REPORT TO THE JOINT REGIONAL PLANNING PANEL (SYDNEY WEST)

Application Numbers:	DA/62/2013/B and 62/2013/D
Address:	1 Parramatta Square, being No. 3 Smith Street Parramatta (formerly No. 169 Macquarie Street and 1A Civic Place Parramatta)
Property description:	Lot 1 DP 1192394
Proposal:	15 storey building over basement parking
Date lodged:	15 January 2015 and 9 March 2015
Applicant	Leighton Properties
Owner	The Trust Company (Australia) Limited
Council Planner:	Myfanwy McNally – Manager, City Significant Development
Report Author:	Brad Roeleven - City Plan Strategy and Development

Figure 3: Figure 4.3.3.7.3 of exhibited draft amendments to DCP 2011 - site circled in red

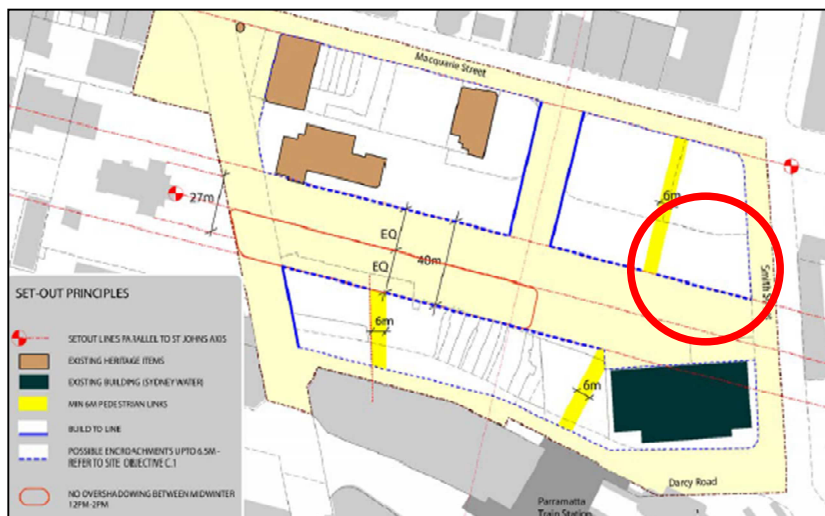
- Retain the 40m width of the main central public square; but
- Allow for consideration of encroachment of building elements at the edges of the main public square up to 6.5m, subject to performance criteria. This is confirmed in revised Figure 4.3.3.7.3 - Public Space Set Out, as shown at Figure 3 below:

The performance criteria to be satisfied to seek an encroachment of the 'build to line' is described in the DCP as follows:

"Encroachments up to 6.5 metres into the 40 metre minimum width zone may be considered where justified by an agreed design excellence rationale."

In response to that criterion the applicant has provided the following contentions:

While arguably the "activation" outcomes will be realised by the approved design it is accepted that:

- The approved building was the subject of a design excellence process, and includes at levels 2-8, a built element that extends south of the main floorplate to within 8m of the Sydney Water site. In that context, extending the ground and first floor levels by a further 3m is of no consequence relative to the relationship of the building with the adjacent public domain;
- It is apparent, through the draft amendments to DCP 2011, that Council is open to greater flexibility in the pattern of buildings along the central open space corridor of Parramatta Square; and
- The amended building will not exceed the 6.5m concession to the southern 'build to line' contemplated for this site.

On balance it is therefore concluded that the enlarged ground and first floorplates, as they relate to the alignment of the northern edge of corridor through this precinct, is acceptable.
